### STATE OF CONNECTICUT CONNECTICUT SITING COUNCIL

DOCKET NO. 471

AND OPERATION OF A WIRELESS TELECOMMUNICATIONS FACILITY AT

### RESPONSES OF CELLCO PARTNERSHIP D/B/A VERIZON WIRELESS TO CONNECTICUT SITING COUNCIL PRE-HEARING QUESTIONS

### **Town of Hamden**

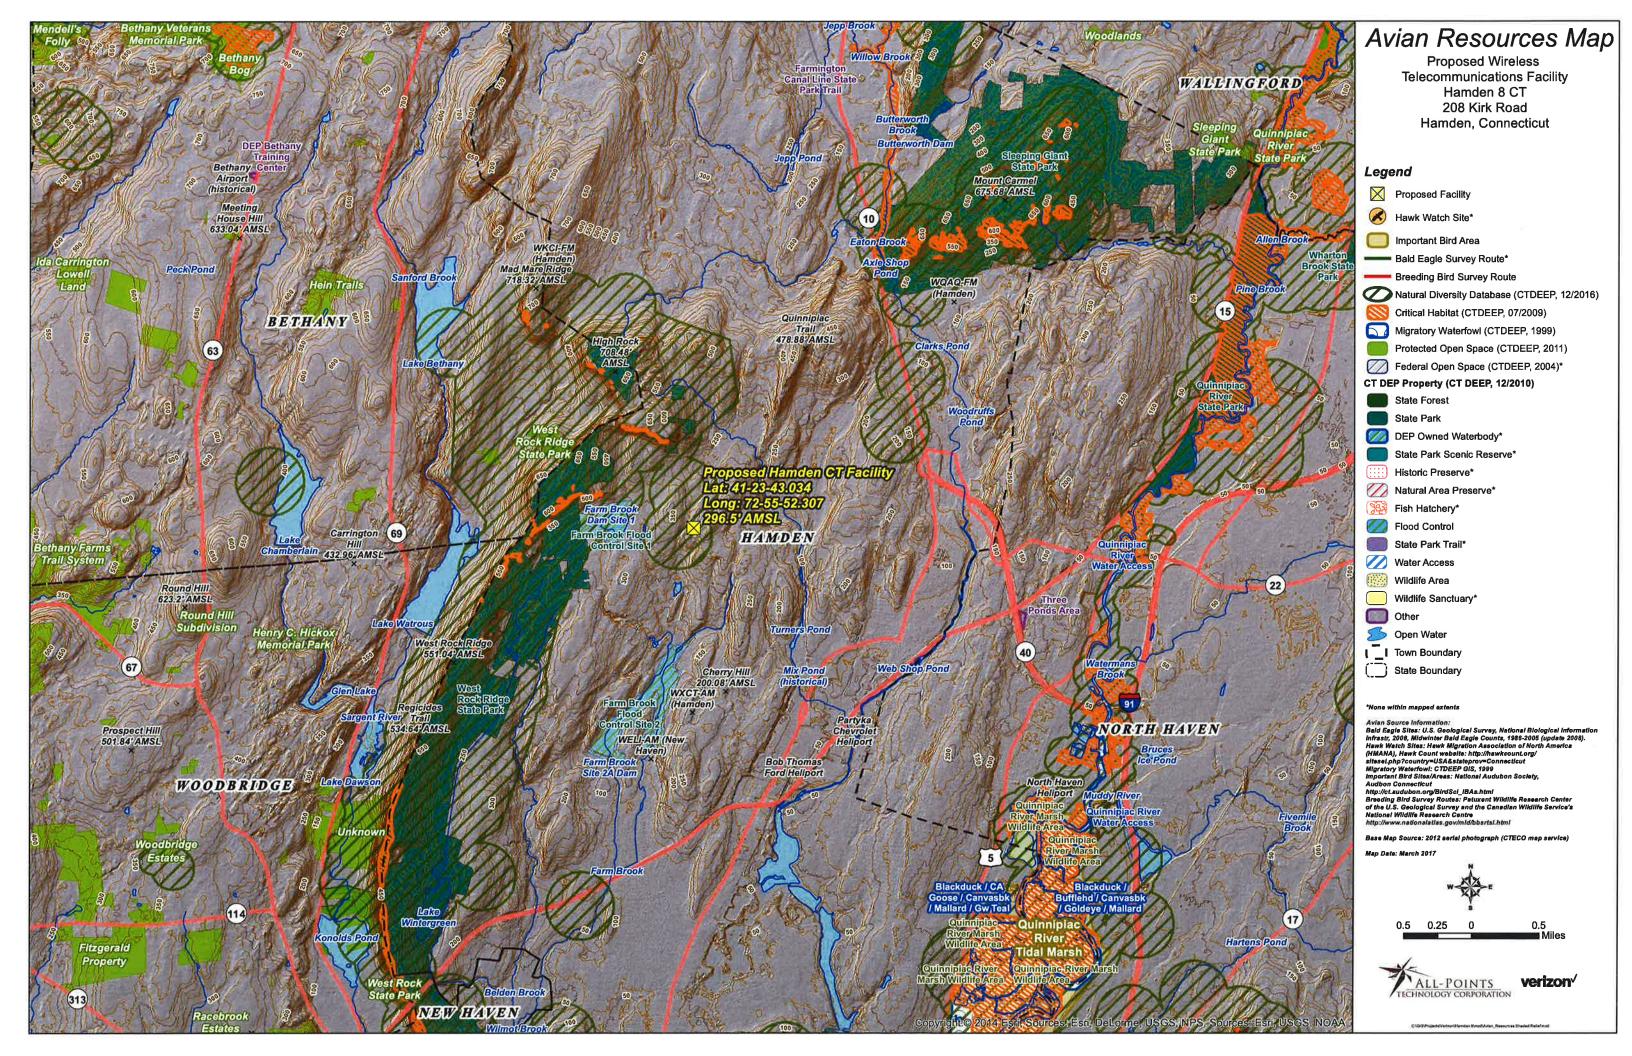
Does Paradise Avenue continue south as a public right-of-way between the Laurel View Country Club and the west side of the site property?

According to the Town Assessor's map the Paradise Avenue Right of Way does not extend beyond the parcel located at 1116 Paradise Avenue. (See Attachment 3).
